### **Re: Design approval for Wellstead Estuary bird hide**

**Title:** Wellstead Estuary – Desktop Review of Proposed Bird Hide Site

**Project:** Wellstead Estuary Bird Hide

# BANGELUNGUP (BREMER BAY RIVER ESTUARY) BIRD HIDE

Figure 10 Concept for FBG Bird Hide on Southern Shore of lower Wellstead Estuary in Bremer Bay.

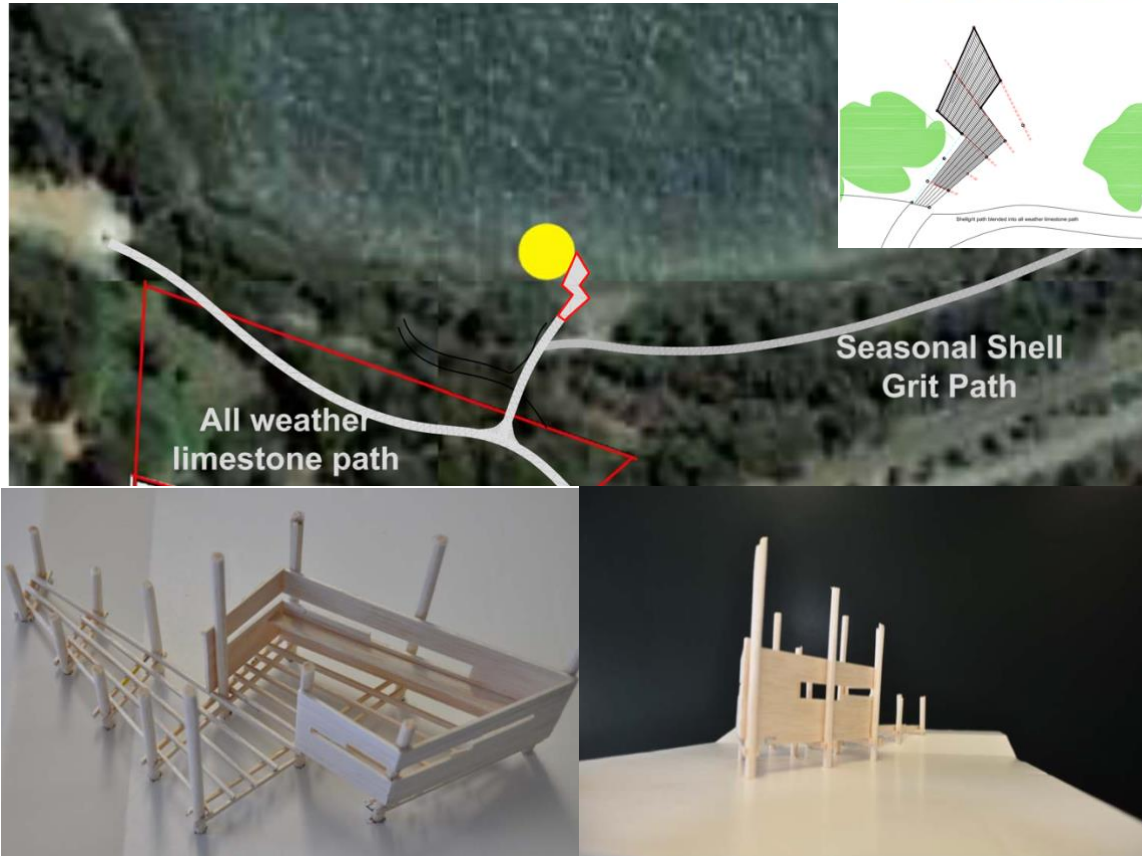
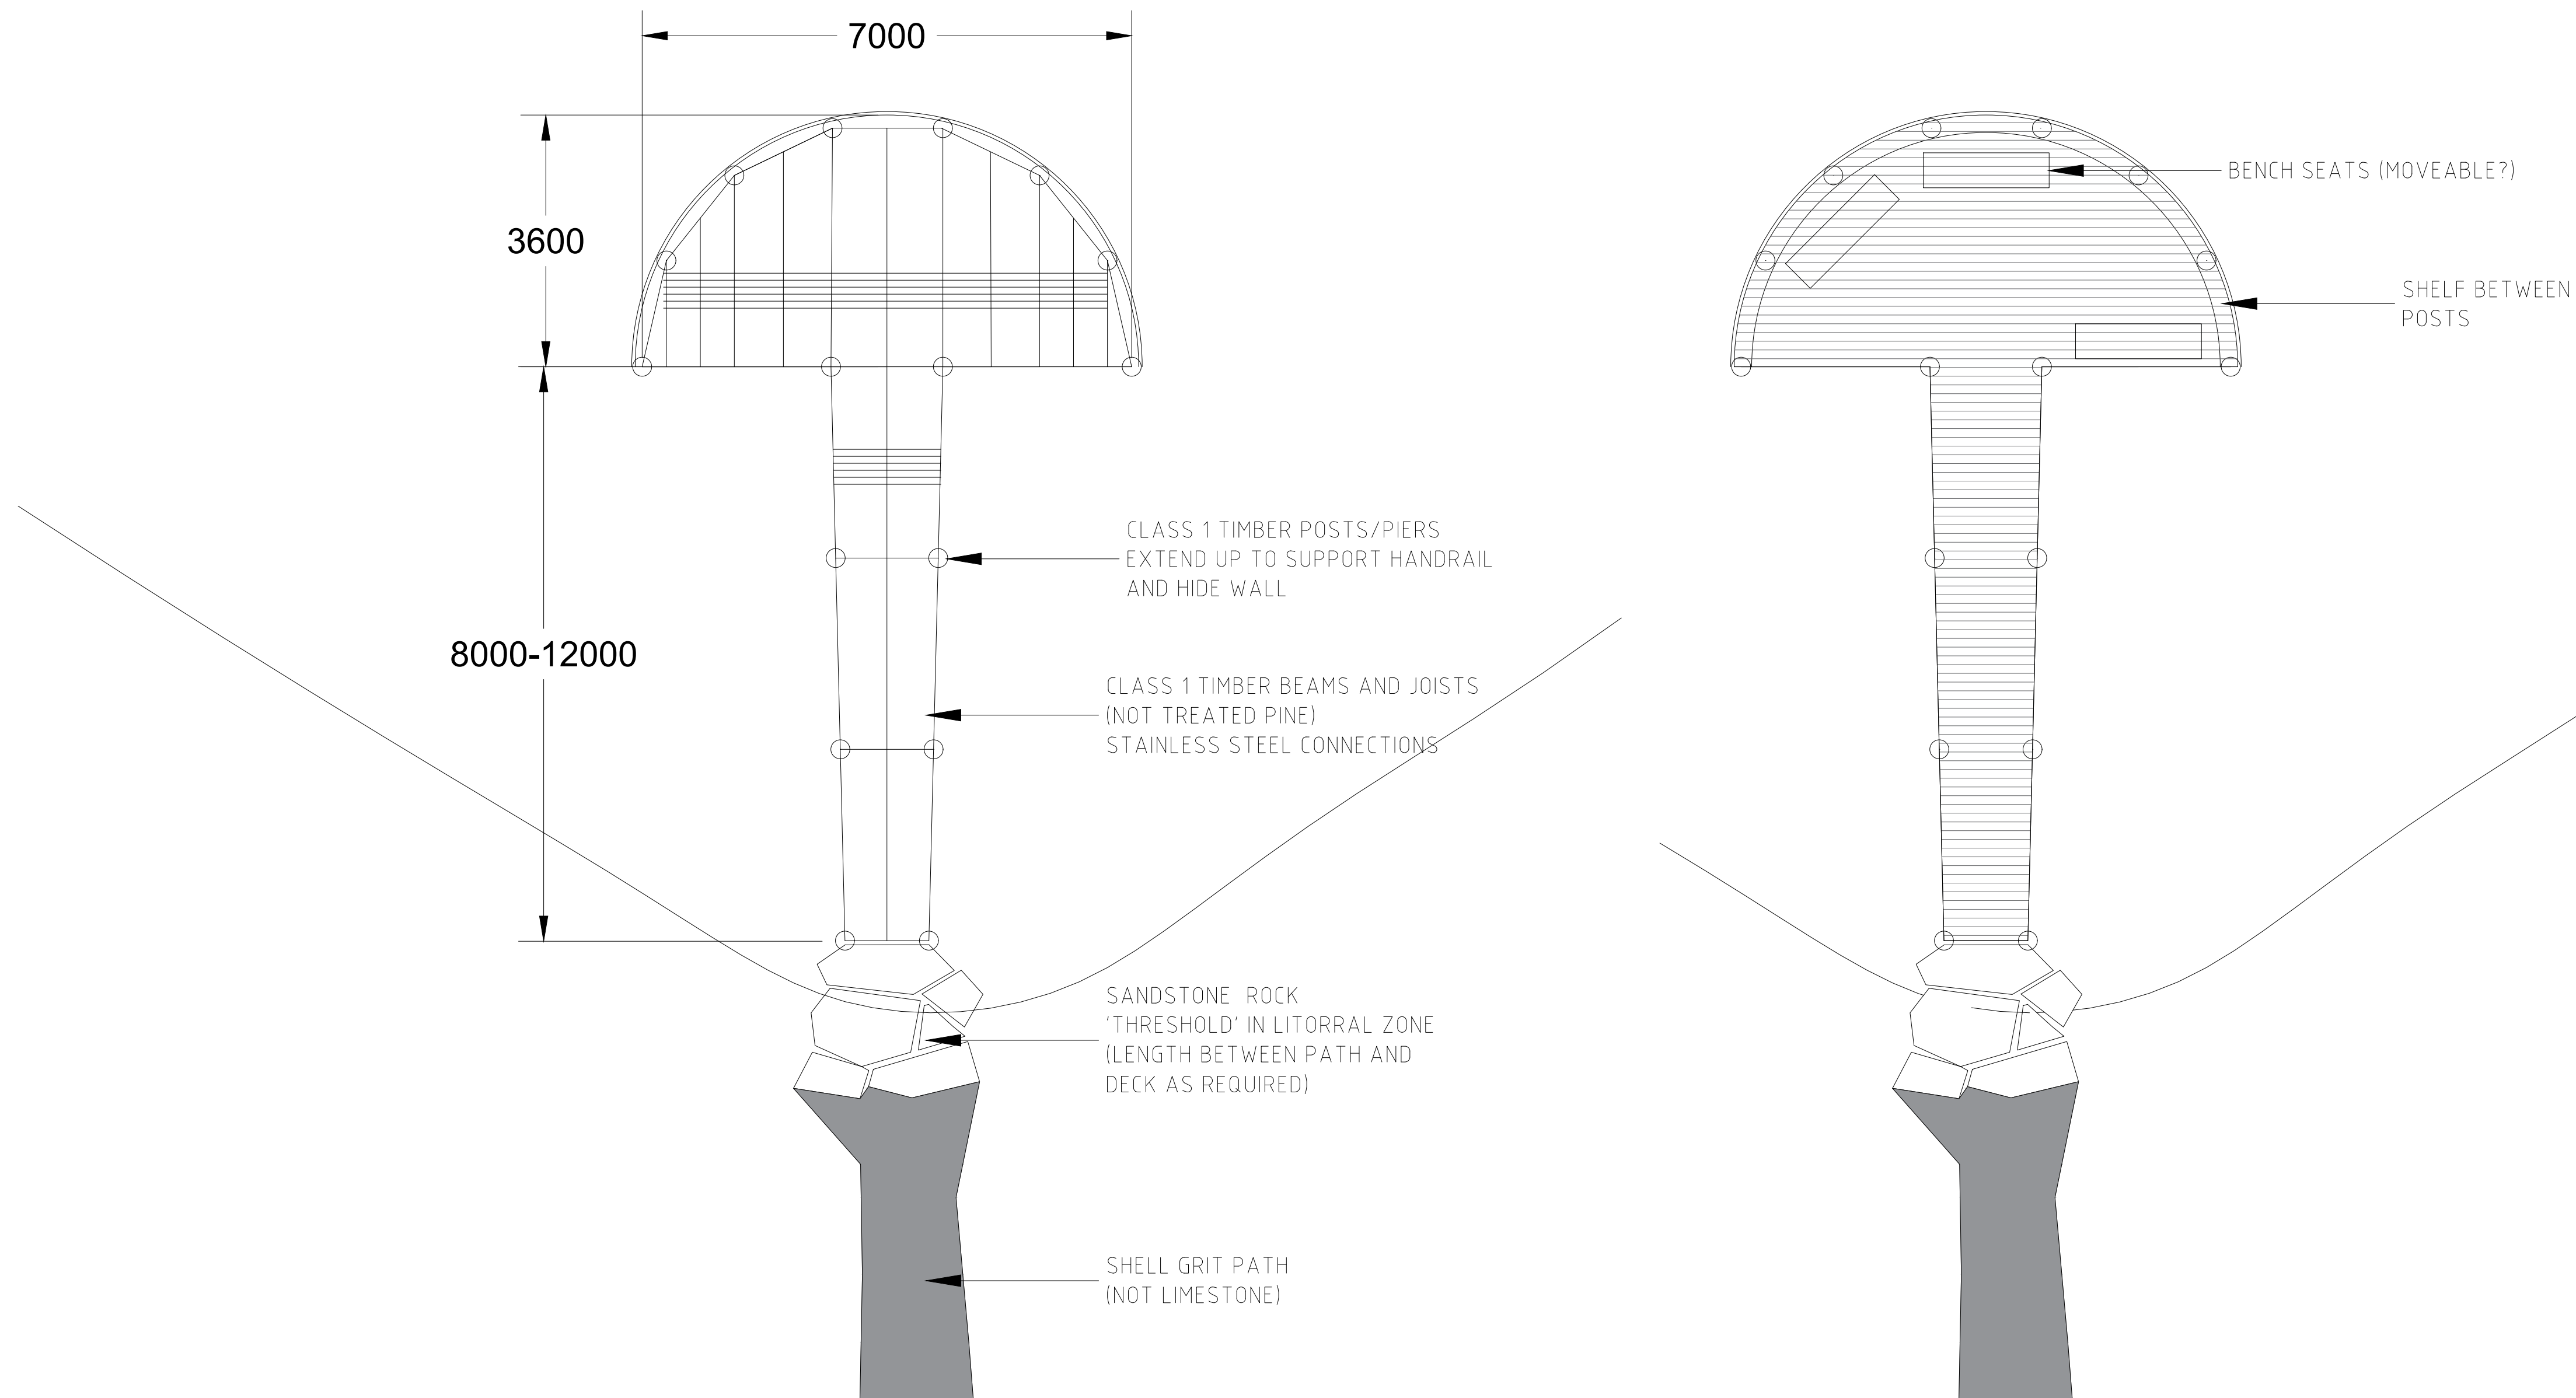
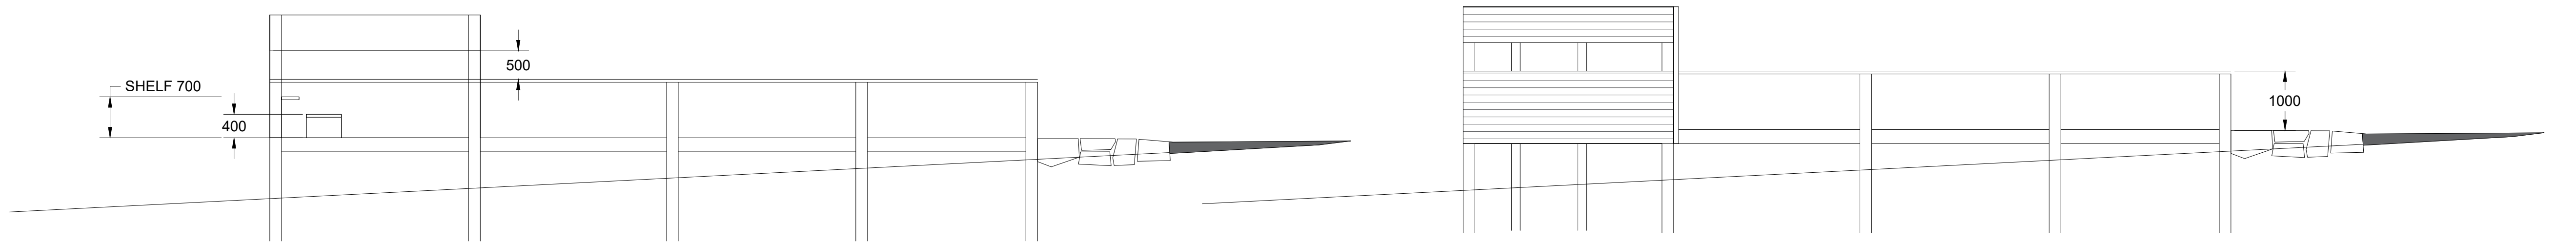
The design concept for the FBG Bird Hide is shown in Figure 9. The concept includes:

- A shell grit path to the walkway.
- A piled timber walkway across the shoreline. The piles are assumed to be timber.
- A piled timber Birdhide at the end of the walkway, with a dogleg from the walkway to the Bird Hide. The Bird Hide includes walling and presumable roofing.

In general the site is considered a suitable location for the proposed design of the bird hide subject to testing of the underlying sediments, and detailed design.

In particular the following requires consideration in further design development:

- **Geotechnical Testing:** Dynamic Cone Penetrometer (DCP) testing and cores at the proposed location of the timber piles, and adjacent areas. Whilst from the evidence available the site appears to be sandy, testing would allow for the potential presence of shell beds, organic matter and silts to be assessed. This testing will determine the suitability of the site and the pile design.

- **Detailed Design:** The following requires consideration in detailed design of the structure:
  - **Location:** Confirm location suitable geotechnically, ties in with paths on land side and avoids shading of marine plants.

- **Timber type** and treatment to ensure longevity in a marine environment, particularly the timber piles (marine grade). Potential timbers include marine grade pine or jarrah.

- **Fixtures:** Hot dip Galvanised or stainless fixing to be considered. Refer AS4997 Guidelines for Design of Marine Structures.
  - **Walkway Decking:** Timber decking likely to be easier to construct, but micromesh grating as used at the Bremer Boat ramp can provide better slip resistance, light penetration and capacity for submergence.

- **Walkway Elevation:** Walkway deck level to ensure it balances occasional submergence at high tides, with the elevation above ground level at lower tides (i.e. requirement for handrails, refer relevant codes). In general deck should be above 1.0m AHD with decking designed for occasional submergence.

- **Shell Grit Path:** Transition from walkway to shell grit path to ensure acceptable grades (refer relevant codes), smooth transition, mitigation of erosion risk to path at higher tides and allowing sediment movement along the shoreline (i.e. don't bring the shell grit path too far forward).

- **Structural Design:** Wind impacts on the structure (wind code).
  - **Drainage:** Local drainage associated with the path (i.e. limit scour paths for rainfall).
